ADDENDUM NUMBER 2

MILWAUKEE COUNTY ZOOLOGICAL GARDENS
AQUATIC REPTILE CENTER
HVAC EQUIPMENT REPLACEMENT AND
SOLAR WATER HEATING SYSTEM ADDITION
Site #355, Bldg. #4440
10001 West Bluemound Road
Milwaukee, WI

Project Number: Z014-09475

Date of Addendum: March 28, 2012

M9

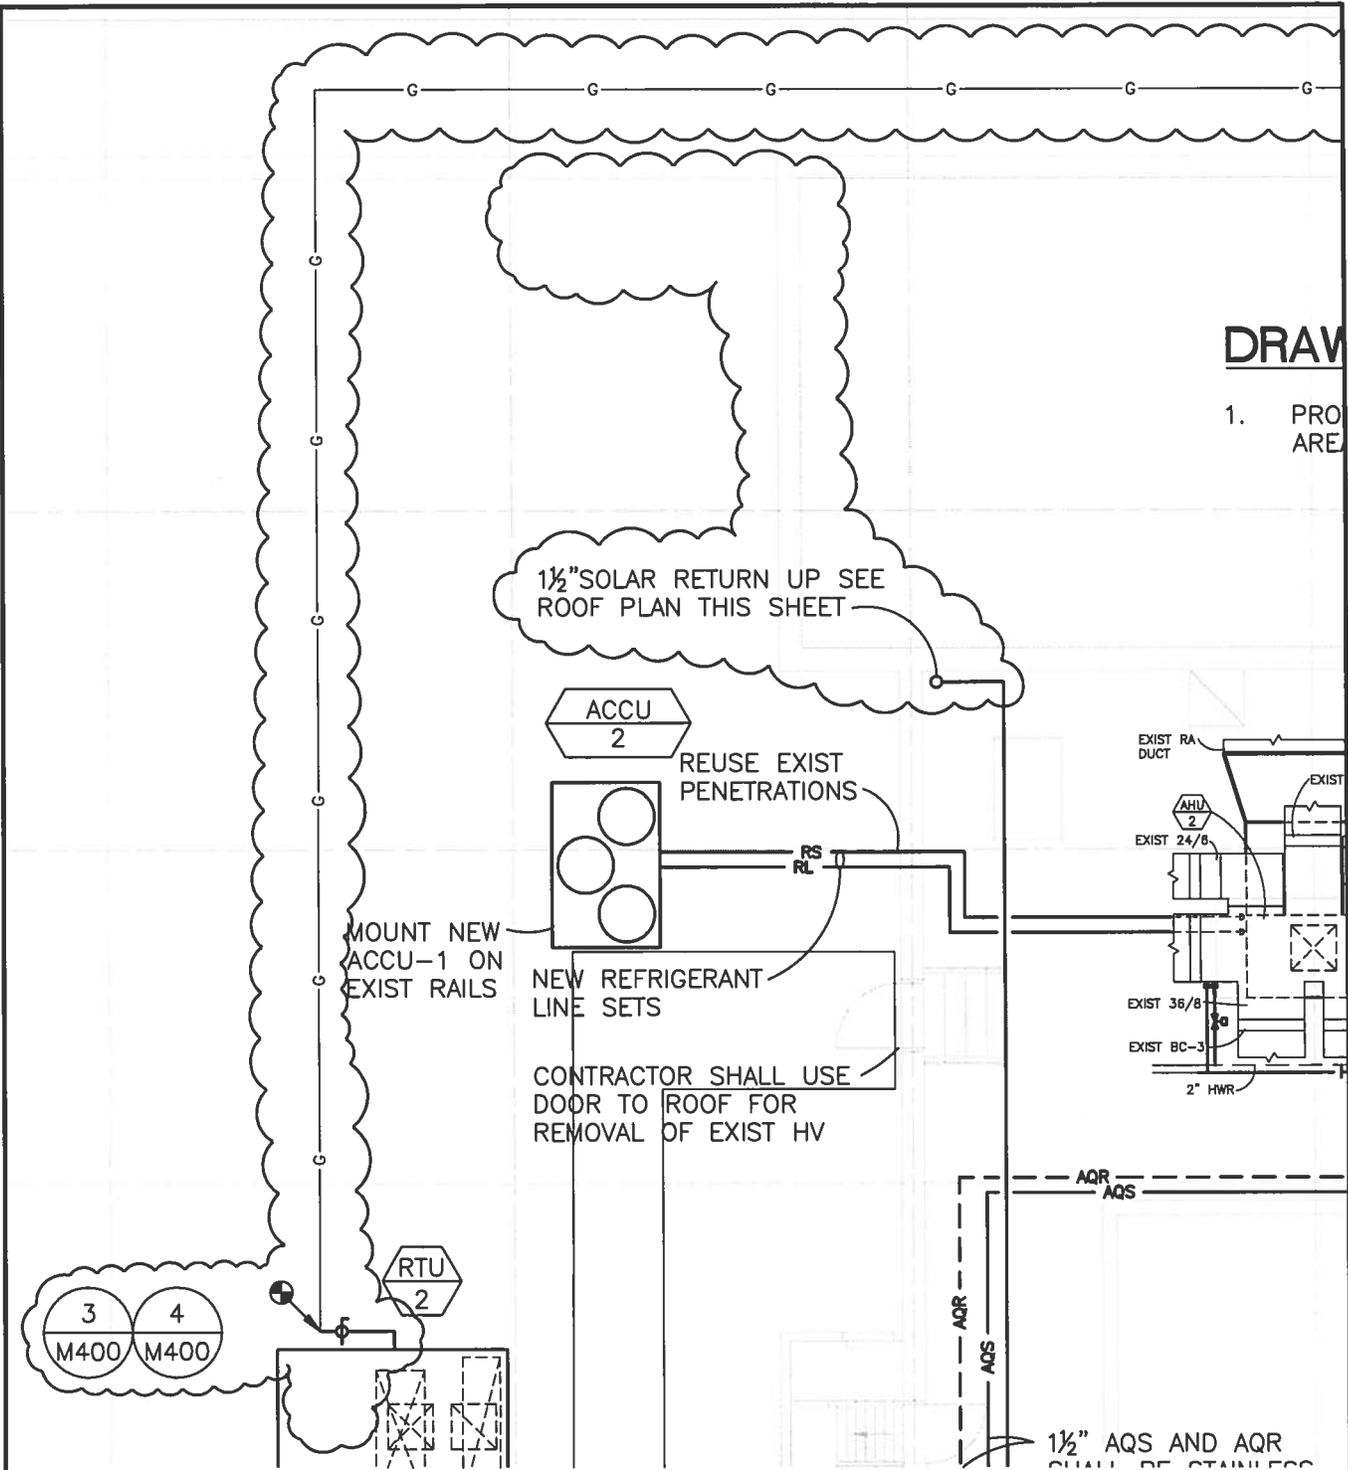
26. Remove existing t-stats symbols in vestibule and revise Alternate 1 to Alternate A as shown in attached sketch M8.
27. Move existing Alternate A note out of boundary and add space between note at "eqpt connect". as shown in attached sketch M9.

M10

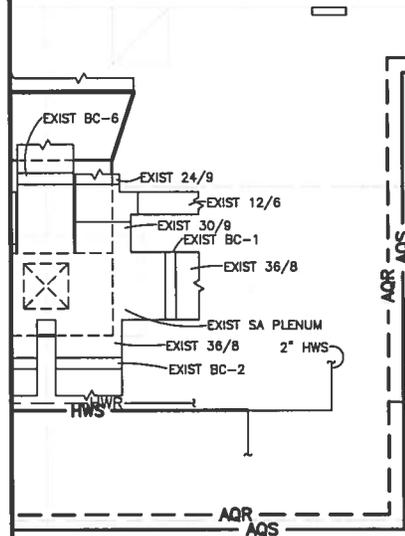
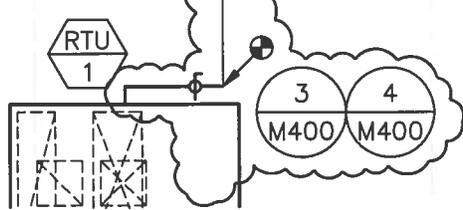
28. Add existing natural gas piping and move 1 ½" solar return pipe from mezzanine roof as shown in attached sketch M10.
29. Add existing natural gas piping and detail bubbles as shown in attached sketch M11.
30. Add existing natural gas piping and detail bubbles as shown in attached sketch M12.

EXIST HWS/R
1 1/2\" AQS/R DN
SEE SHEET M201 FOR CONTINUATION

1 1/2\" AQS AND AQR SHALL BE STAINLESS STEEL PIPES
